EQUIPMENT AFFECTED: BME S-Band Masthead Transceivers 65830M **, N ** and Bulkhead Transceivers 65831A, B

OBJECT AND METHOD: To reduce RF Leakage affecting AFC performance

Figure 3 – Attach shims

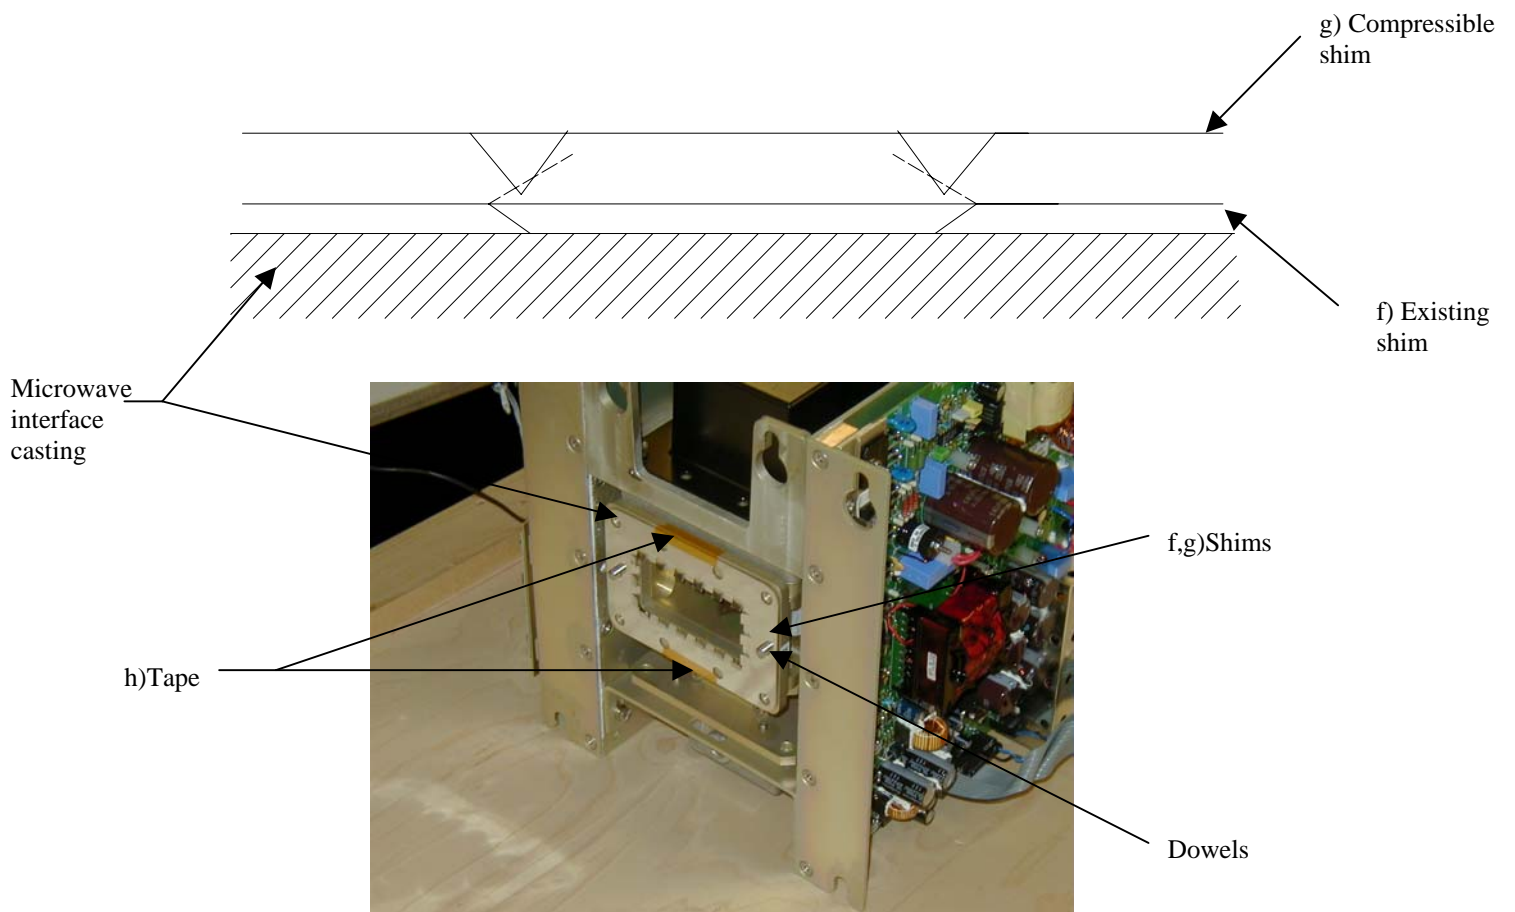
- Referring to figures below, attach compressable shim, g, item 1, over dowel pins and existing shim (f) in orientation shown and hold in place using 2 pieces of tape, (h), from item 2.

Figure 4 – Remove Coax cable

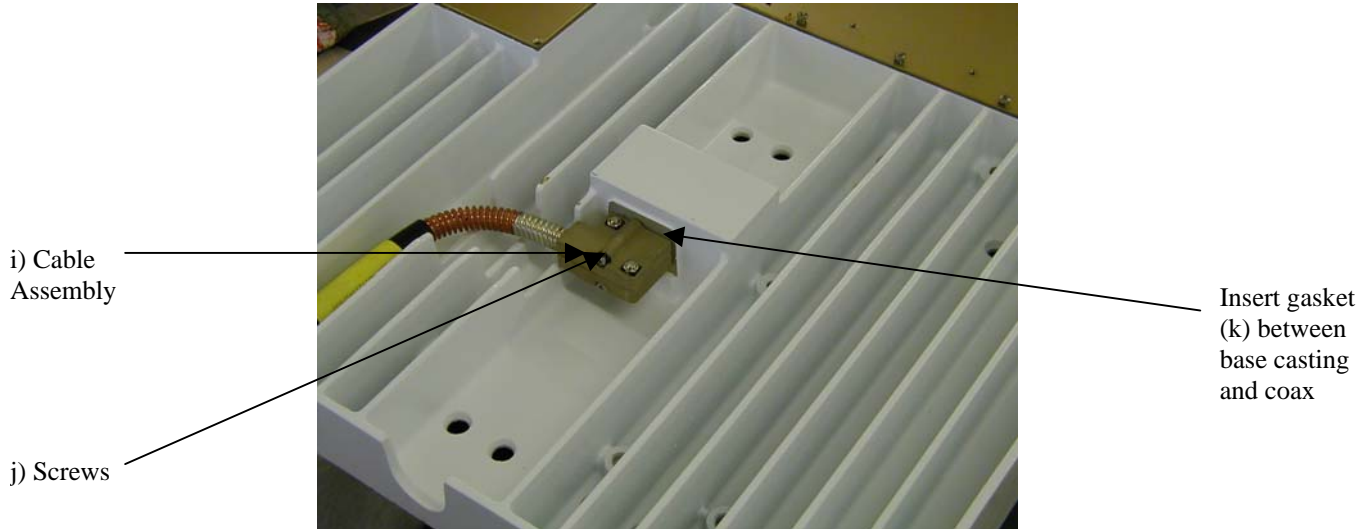
- Remove coax cable assembly (i) by undoing 2 off fixing screws (j) being careful not to damage the probe.
- Refit coax cable assembly (i) placing gasket (k), item 3, between cable and base casting and replace 2 off screws (j)
- Refit transceiver casting to bulkhead and reconnect cables if required
- Replace transceiver and tighten 6 off fixing bolts.
- Re-attach 4 off cables (figure 1 a,b,c,d)
- Replace Transceiver cover
- Reconnect mains supply, switch on radar and check for normal operation.

Figure 7 – Attach shims

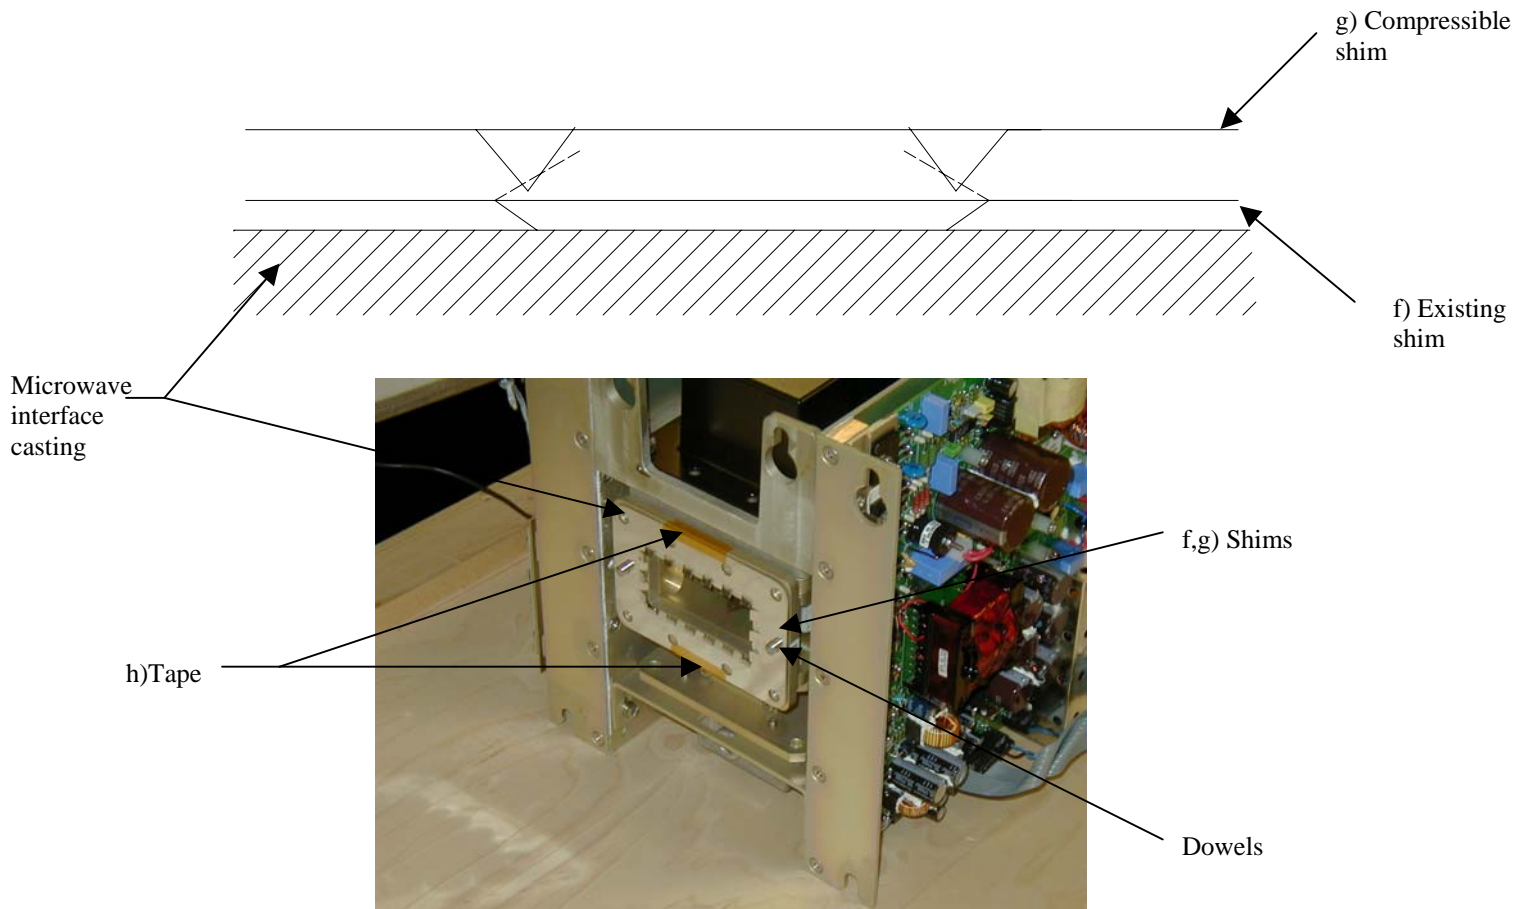
6. Referring to figures below, attach the compressable shim, item 1, over dowel pins and existing shim (f) in orientation shown and hold in place using 2 pieces of tape (h), from item 2.

Figure 8 – Remove Coax cable (view from inside turning unit)

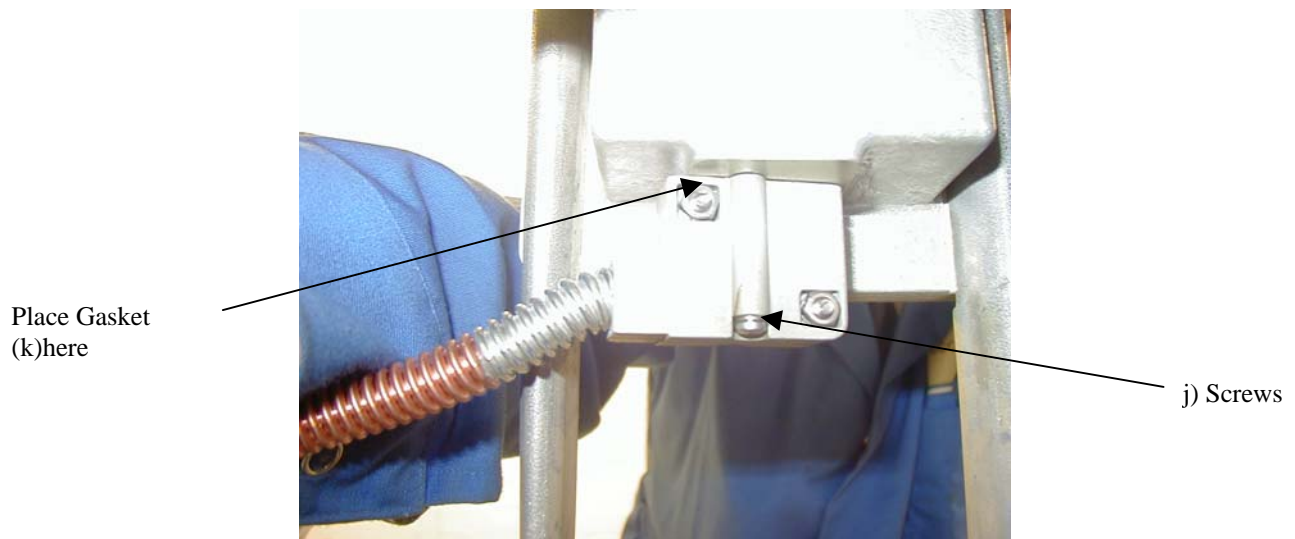
7. Disconnect the coax cable, (i), from the turning unit transition by removing 2 off screws, (j), being careful not to damage the cable by over forcing.

8. Refit coax cable, (i), placing gasket, (k), item 3, between cable and transition and replace 2 off screws (j)
